**SET HEARING FOR VACATION AND CONVEYANCE OF A SEGMENT OF
INGERSOLL AVENUE RIGHT-OF-WAY ADJOINING
525 17TH STREET TO ARTISAN ROW, LLC IN EXCHANGE FOR
A COMPARABLE PARCEL OF LAND ADJOINING 1623 GRAND AVENUE**

Hubbell Realty Company, Ingersoll Avenue Right-of-Way between 16th & 17th Streets 11-2013-1.18

Communication from the City Plan and Zoning Commission advising that at their meeting held December 5, 2013, the following action was taken regarding a request from Hubbell Realty Company (purchaser) represented by Steve Niebuhr (officer) for review and approval of a Site Plan "Artisan Row" under design guidelines for multiple-family dwellings on property located at 1623 Grand Avenue and 525 17th Street to allow development of 27 two-story row dwellings and for vacation of an irregular segment of Ingersoll Avenue right-of-way lying south of the travelled portion of the street between 16th Street and 17th Street, to incorporate within the proposed development site on that block. The subject property is owned by Meredith Corporation.

APPROVAL of a Site Plan "Artisan Row" under design guidelines for multiple-family dwellings to allow development of 27 two-story row dwellings subject t

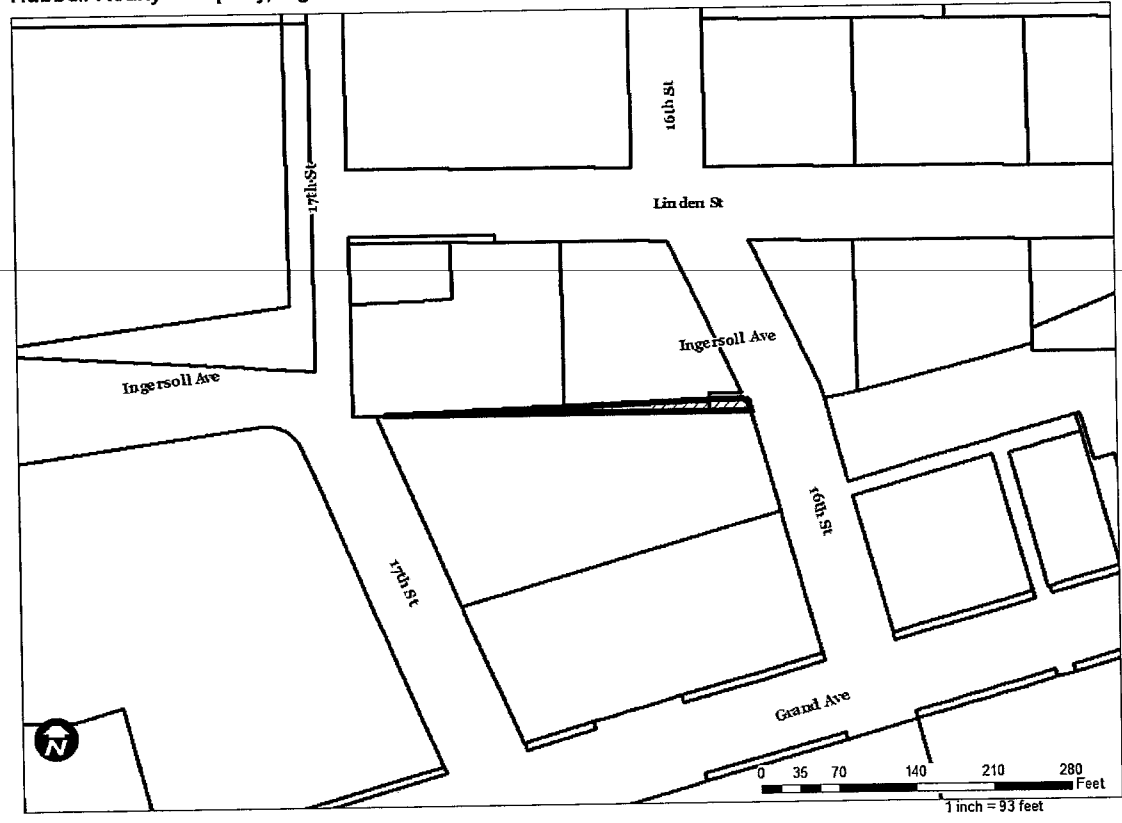
Request from Hubbell Realty Company (purchaser), 525 17th Street, represented by Steve Niebuhr (officer). The adjoining subject property is owned by Meredith Corporation.				File # 11-2013-1.18		
Description of Action	Vacation of an irregular segment of Ingersoll Avenue right-of-way lying south of the travelled portion of the street between 16th Street and 17th Street, to incorporate within the proposed development site on that block					
2020 Community Character Plan	High-Density Residential (current & no change proposed)					
Horizon 2035 Transportation Plan	No Planned Improvements					
Current Zoning District	"R1-80" One-Family Residential and "R-3" Multiple-Family Residential					
Proposed Zoning District	N/A					
Consent Card Responses	In Favor	Not In Favor	Undetermined	% Opposition		
Inside Area						
Outside Area						
Plan and Zoning Commission Action	Approval	13-0	Required 6/7 Vote of the City Council		Yes	N/A
